Bulletin Number - BP3 Promenade - Bulletin 08

Project	Steamboat Base Village Redevelopment	Date	08/06/2021
Project Location	Steamboat, Colorado	Architect's Project Number	03.7835.000
Owner/Client	Alterra Mountain Company / East West Partners	File	6BL This is page 1 of 2
To	Saunders Construction Inc.	Attention	Bryan Sculthorpe
Address	86 Inverness Place North		
City	Englewood	State	CO Zip Code 80112
Delivered via:	<input type="checkbox"/> Messenger <input type="checkbox"/> Hand carried <input type="checkbox"/> Facsimile <input type="checkbox"/> Express <input type="checkbox"/> Pick-up <input type="checkbox"/> E-mail Address <input type="checkbox"/> Mail <input type="checkbox"/> UPS <input checked="" type="checkbox"/> Website Address BIM360

Description of Changes

② (DE) SITE POWER PEDESTAL - 36" QUAD, SC6369
NO SCALE

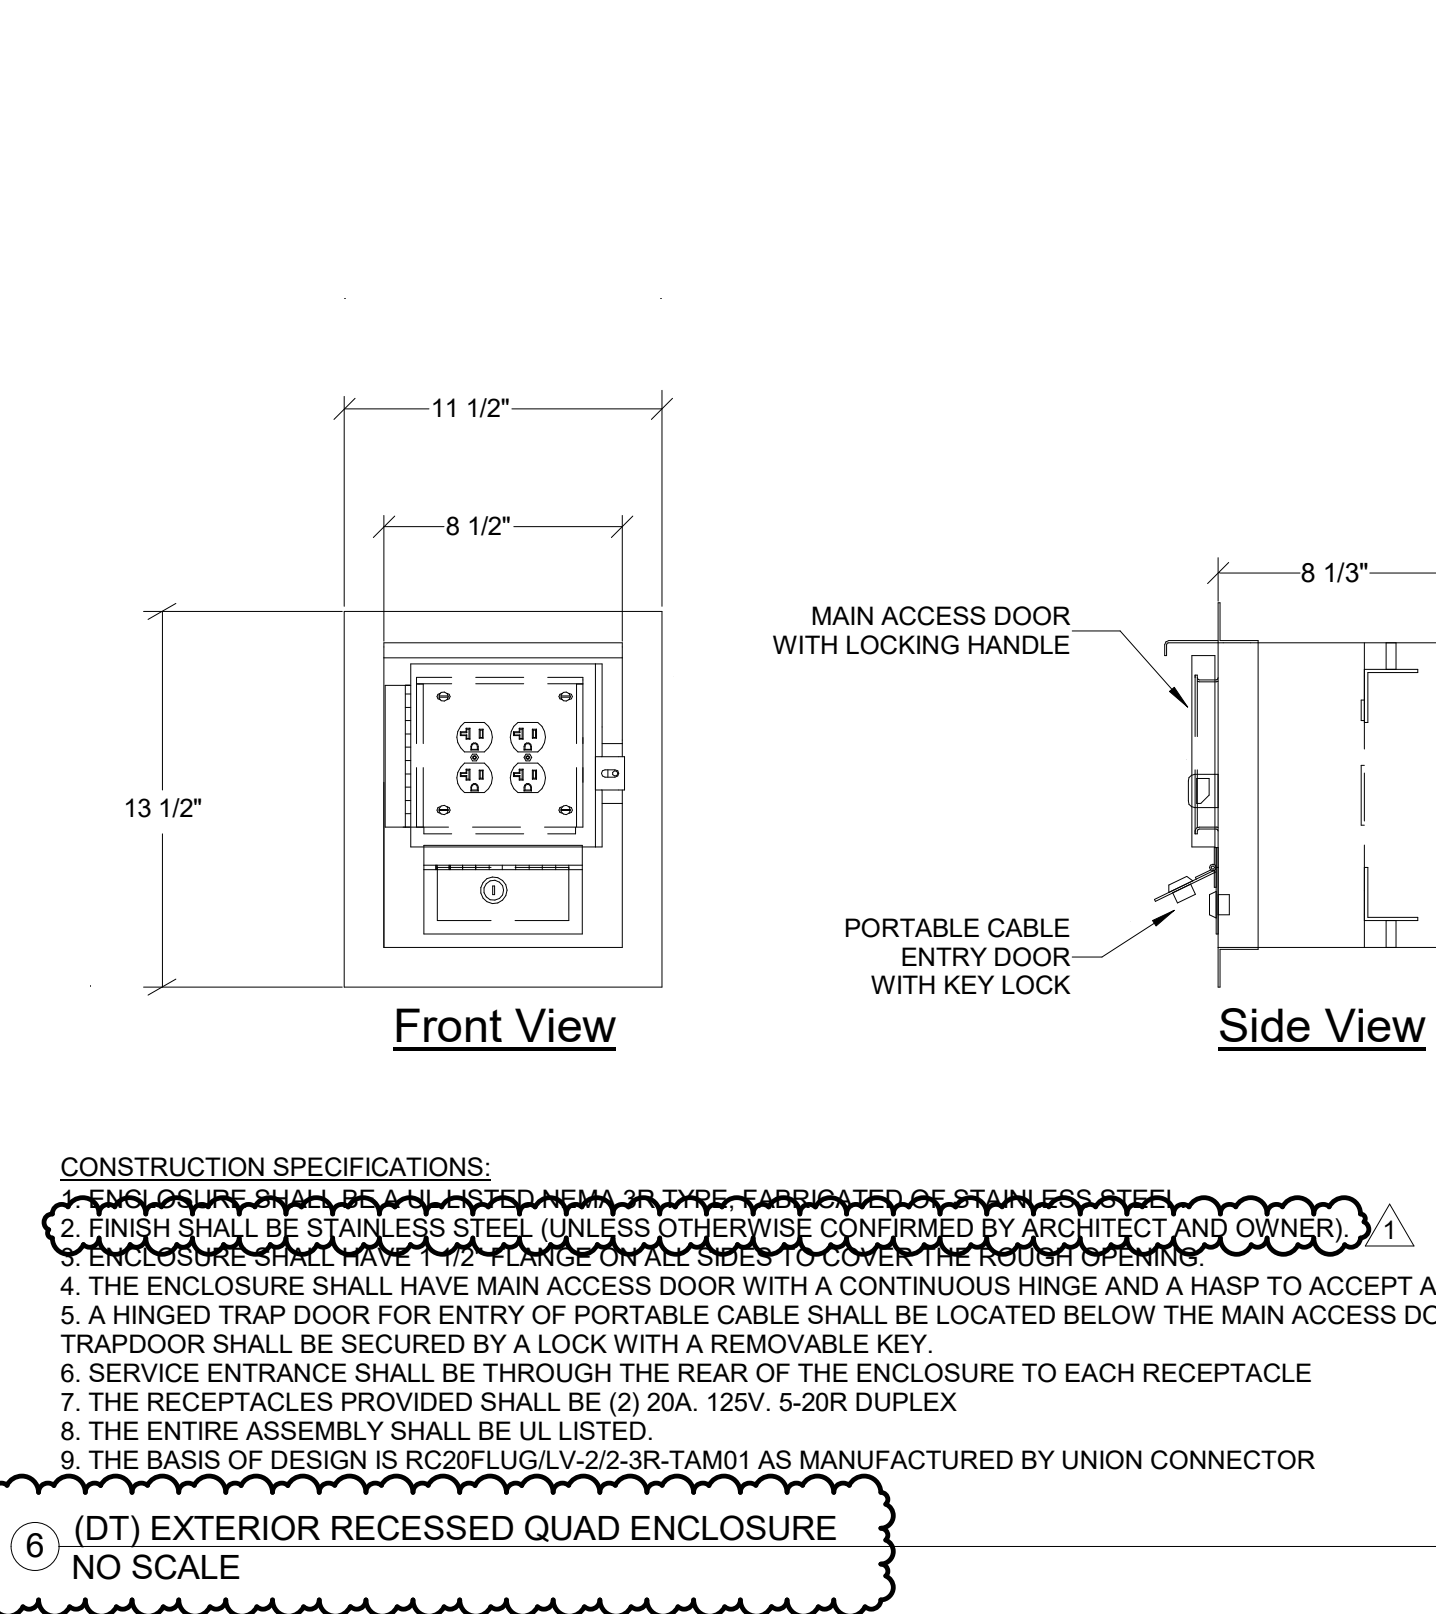
- b. Modified lighting controls matrix to align with design intent and conversations with lighting controls rep.
- 34. 1A-E8.002
 - a. Modified plaza details for added clarity to design intent of plaza pedestals and fire pit EPO buttons.

1A-M1.300

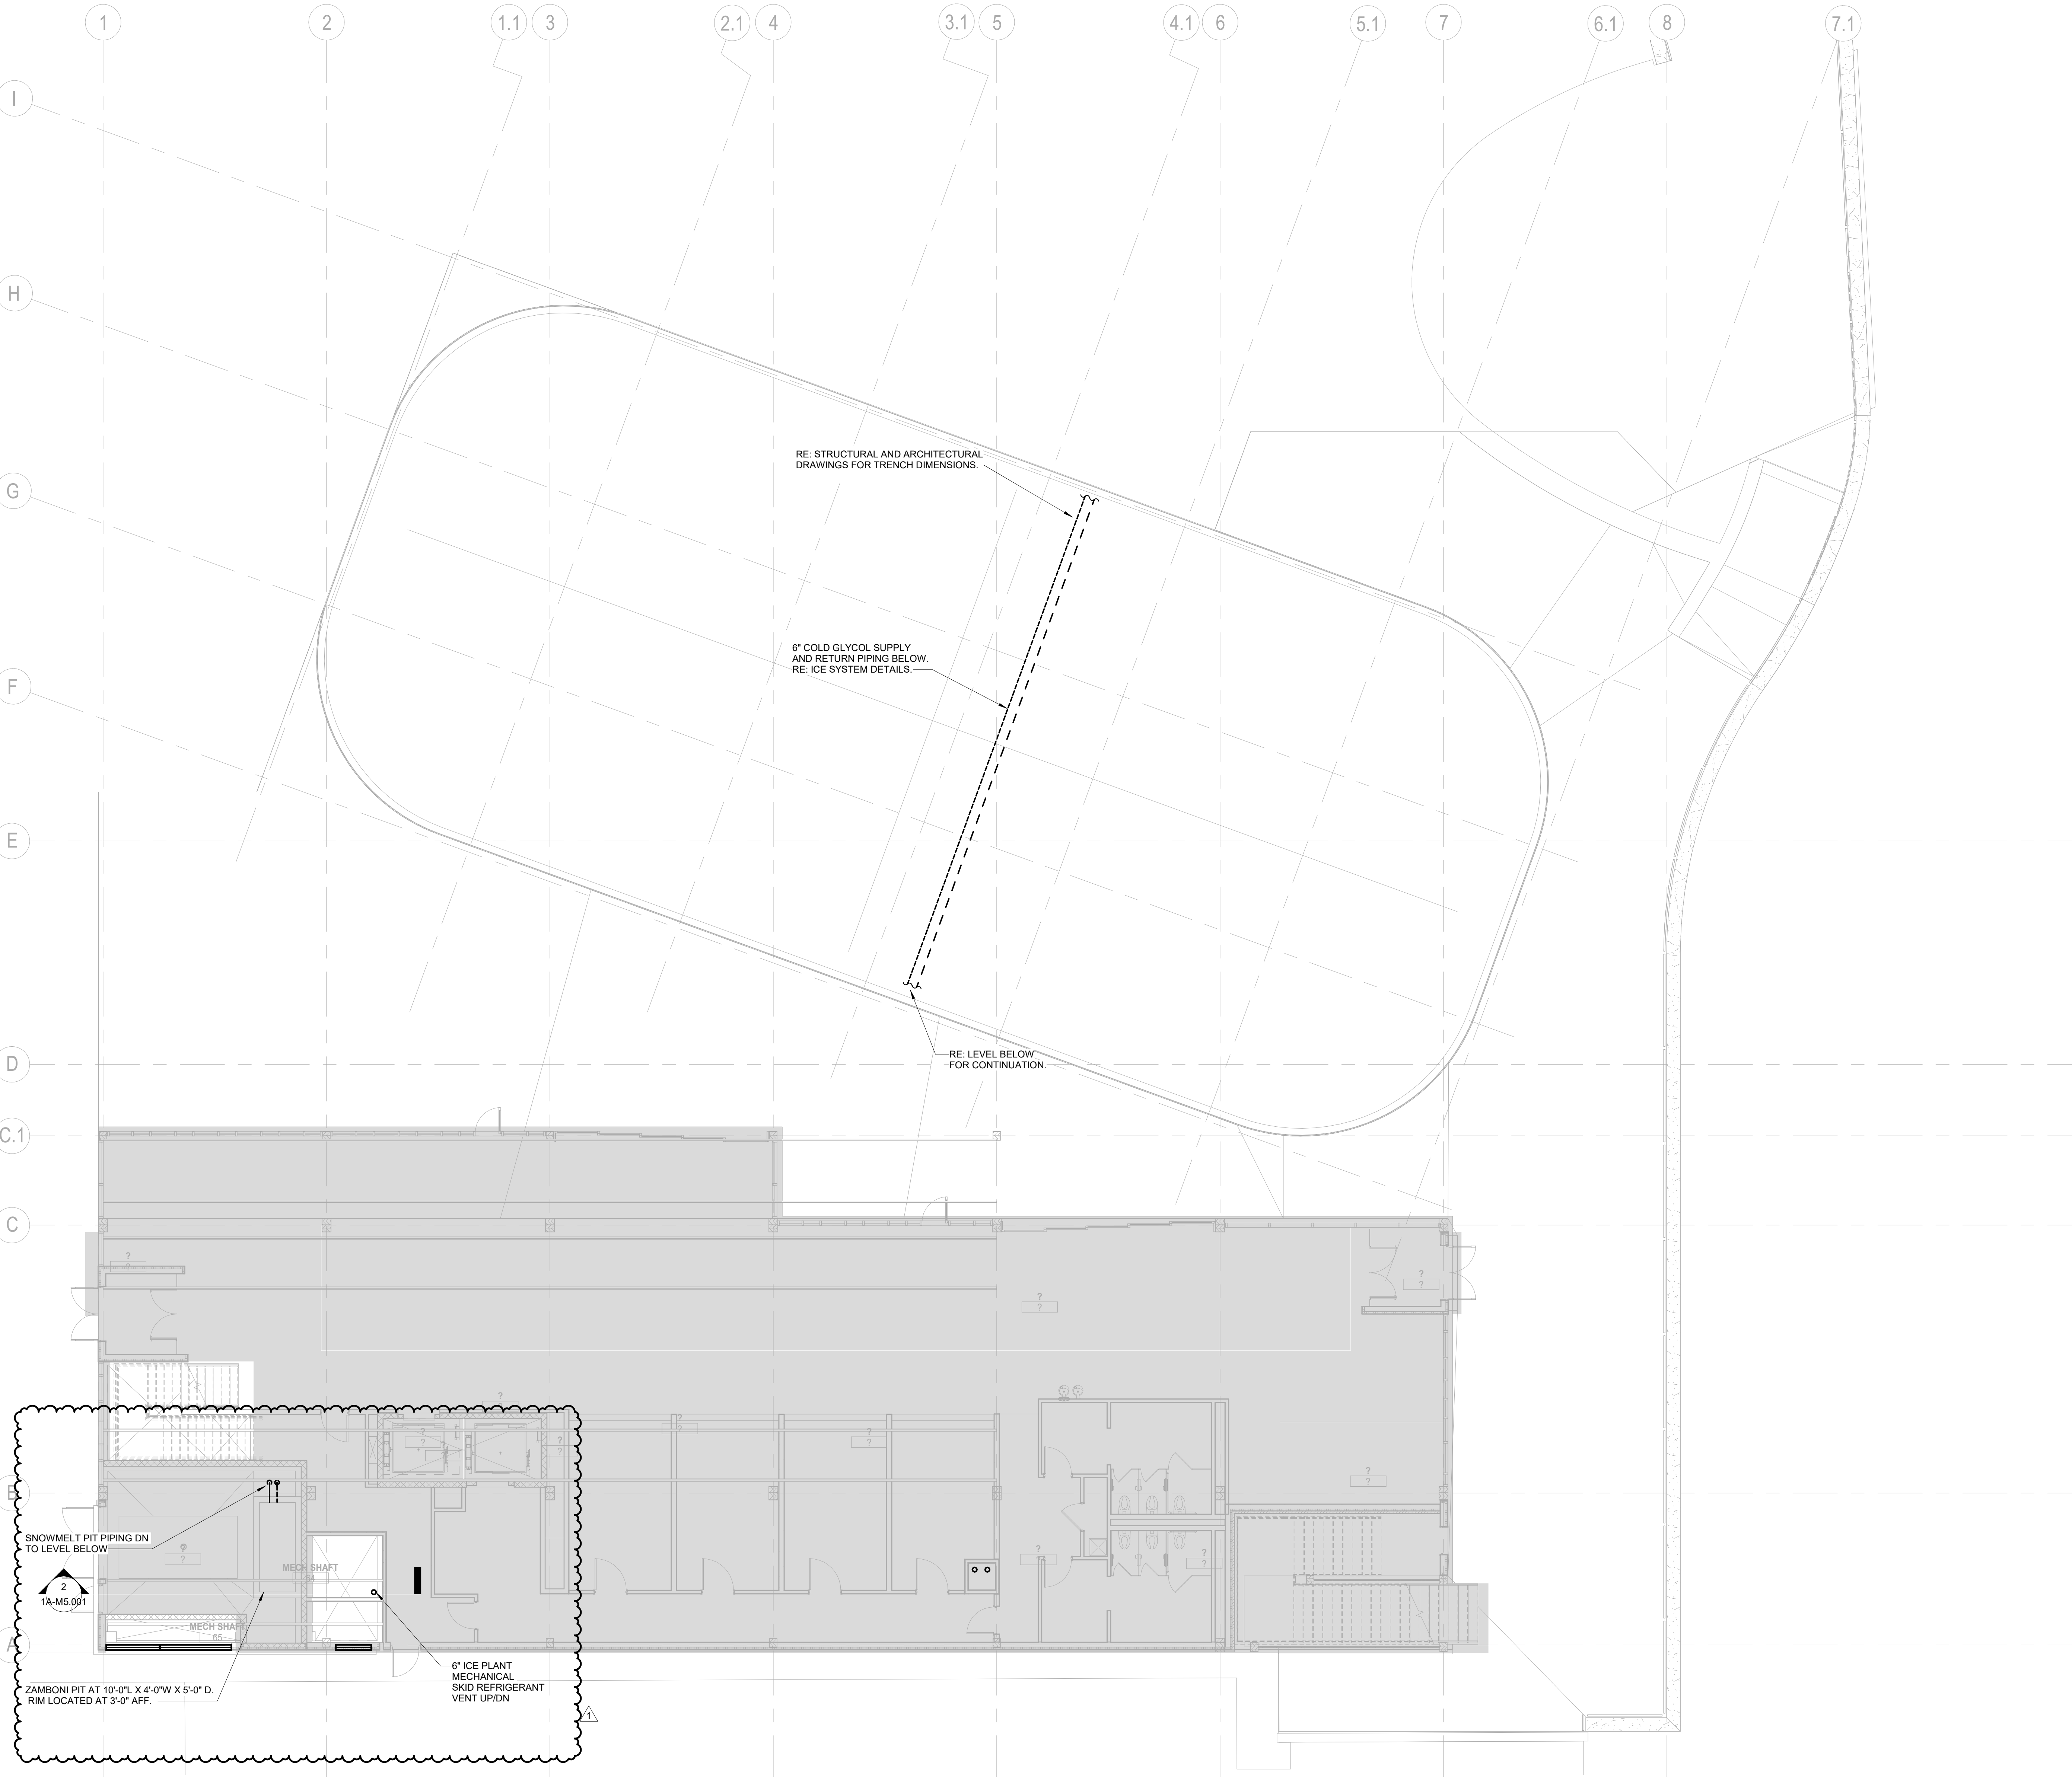
5. 1A-M1.300
 - a. Revised ice plant skid location and revised pipe routing.
6. 1A-M1.301
 - a. Revised refrigerant skid vent riser location.
7. 1A-M1.302
 - a. Heat rejection moved up to Level 2 mechanical yard.

1A-M1.302

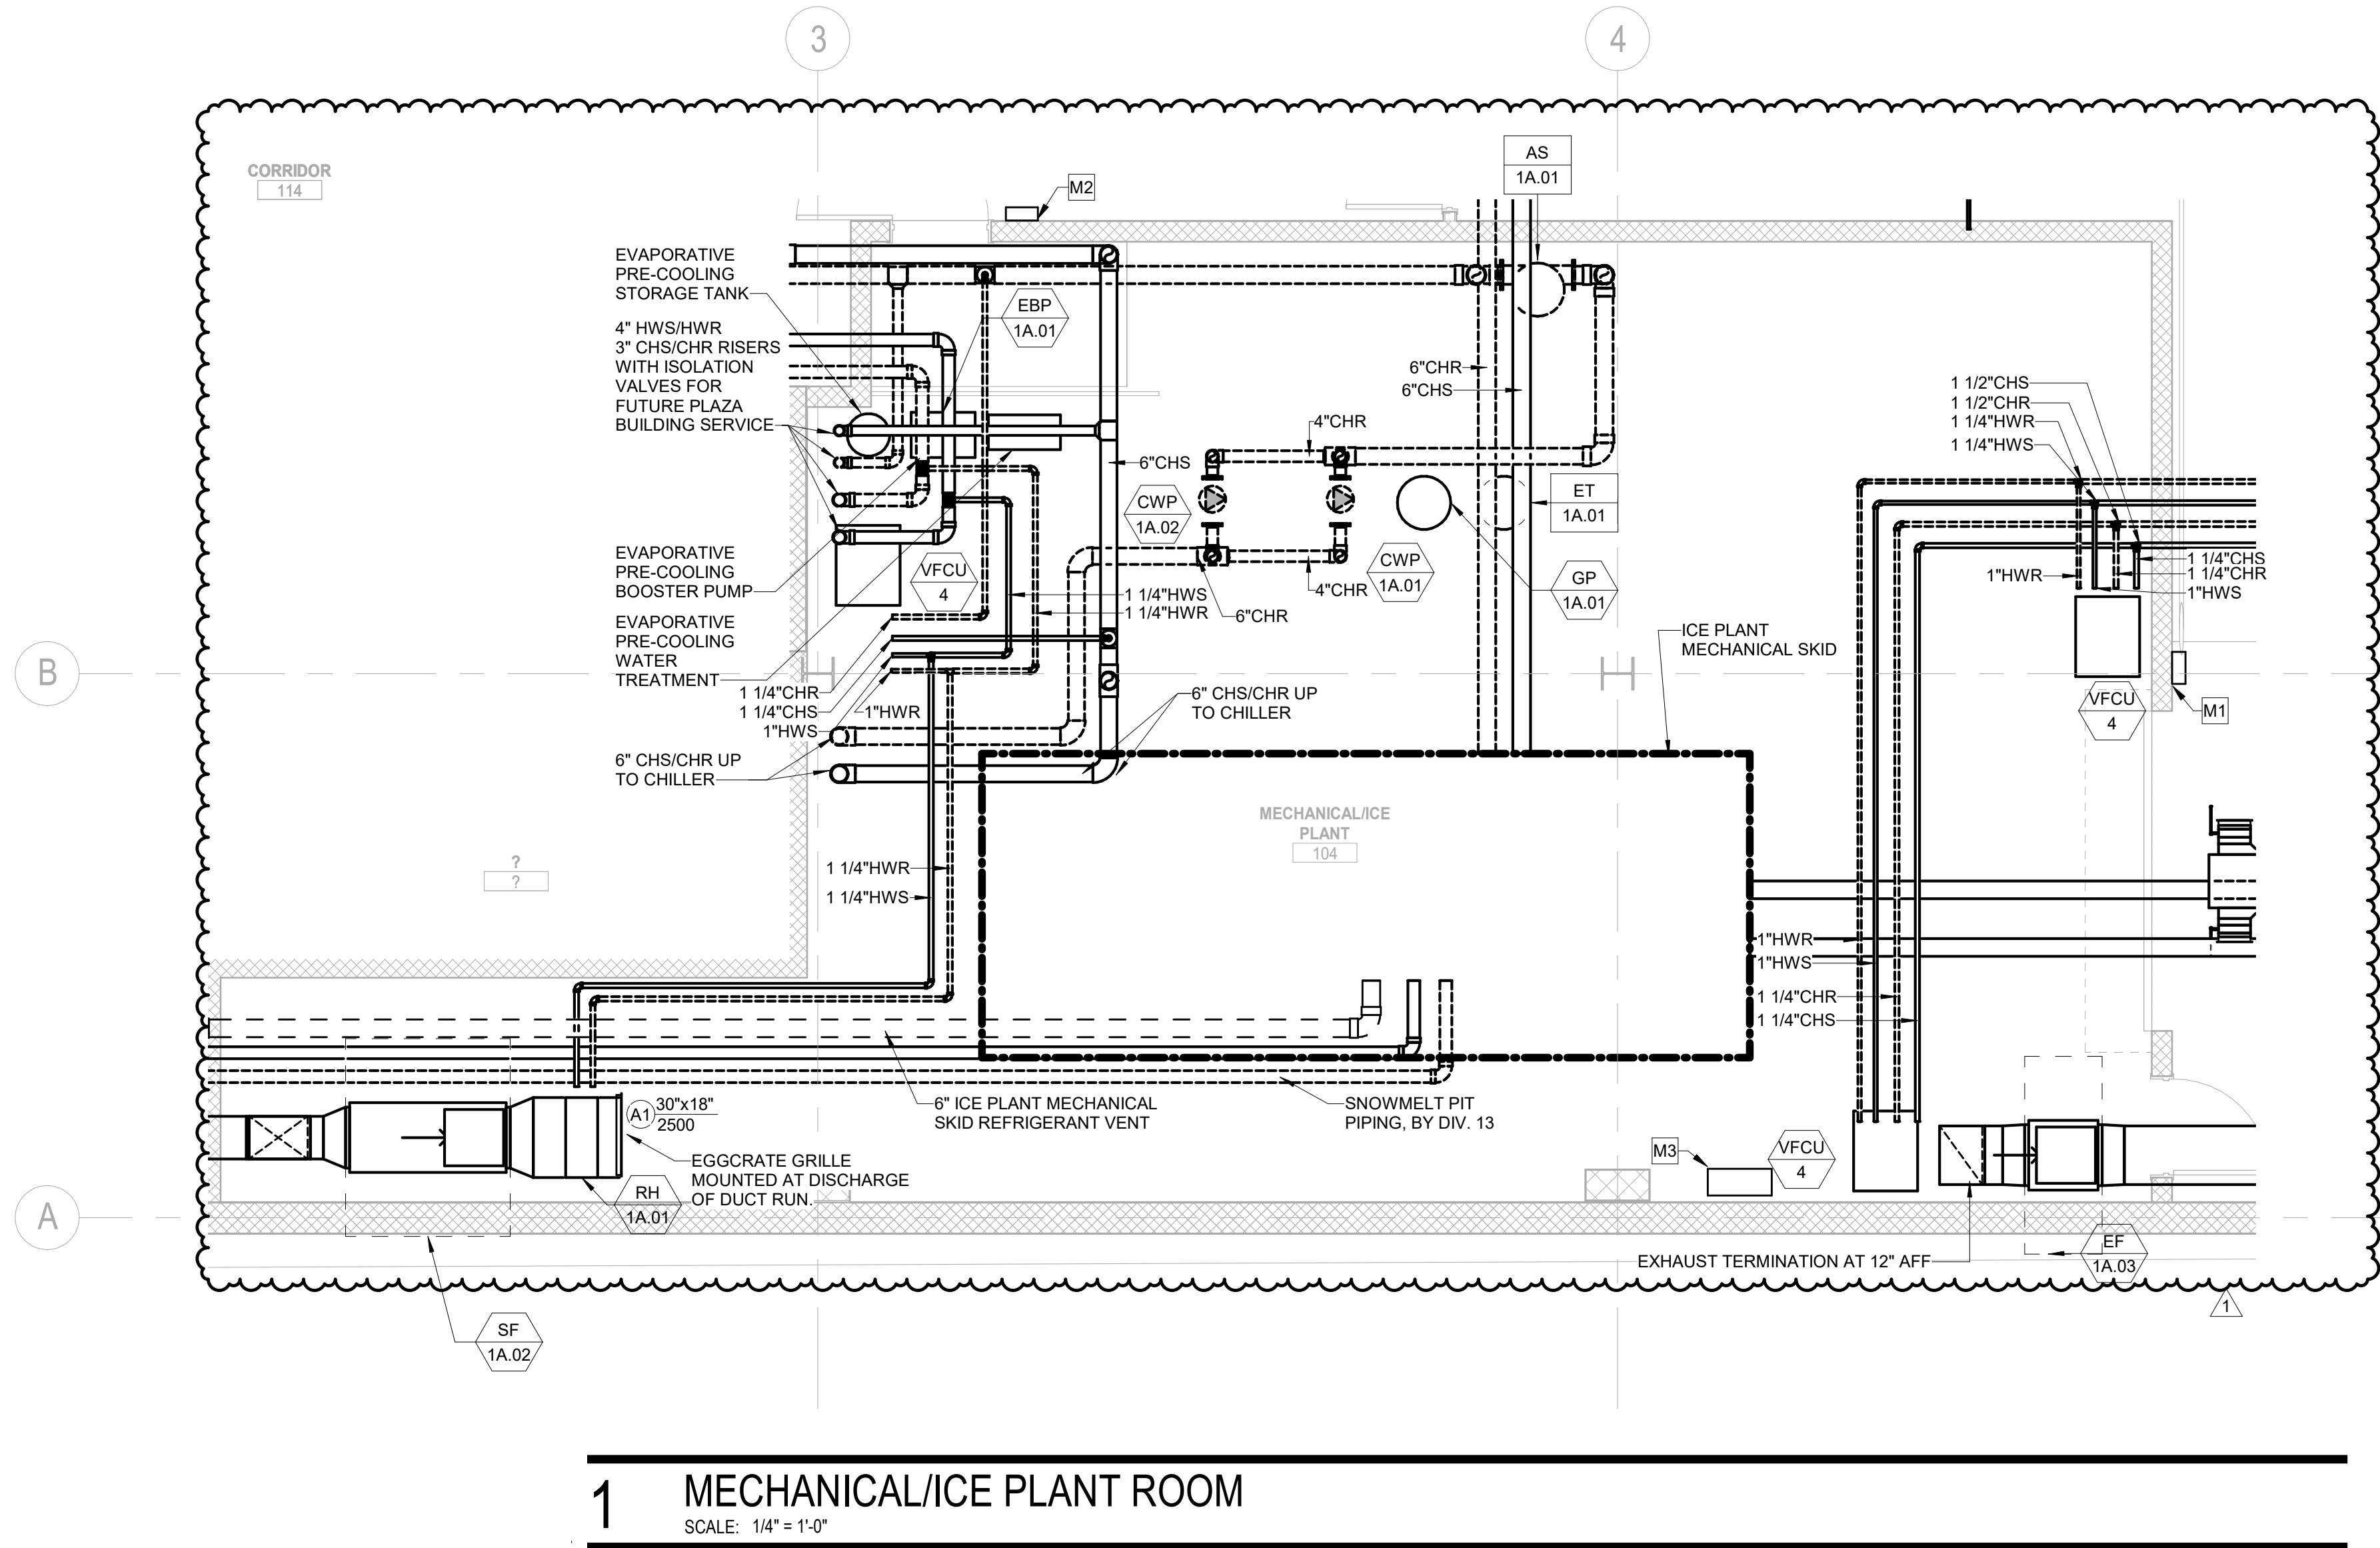
- b. Revised refrigerant skid vent riser location.
8. 1A-M1.400
 - a. Revised mechanical room layout including relocated equipment and controls.
 - b. Revised sheet metal above Zamboni pit.
